IN THE DRAWINGS:

Applicant hereby proposes changes to Fig. 1. A revised Fig. 1 is attached for the Examiner's review and approval.

Fig. 1

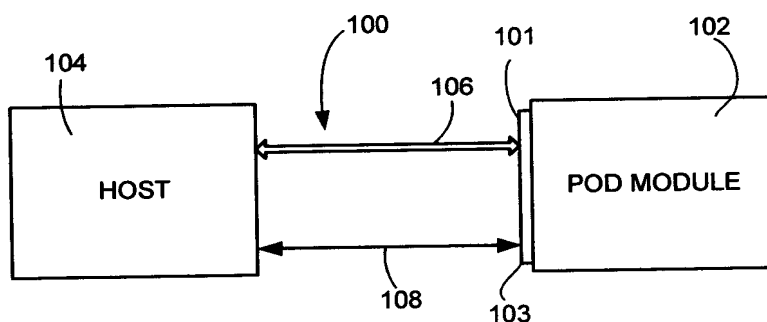
In the revised Fig. 1, block 101 has been added to represent the pins of the interface 100. Additionally, reference number 103 has been added to indicate a particular pin that acts as an interface pin.
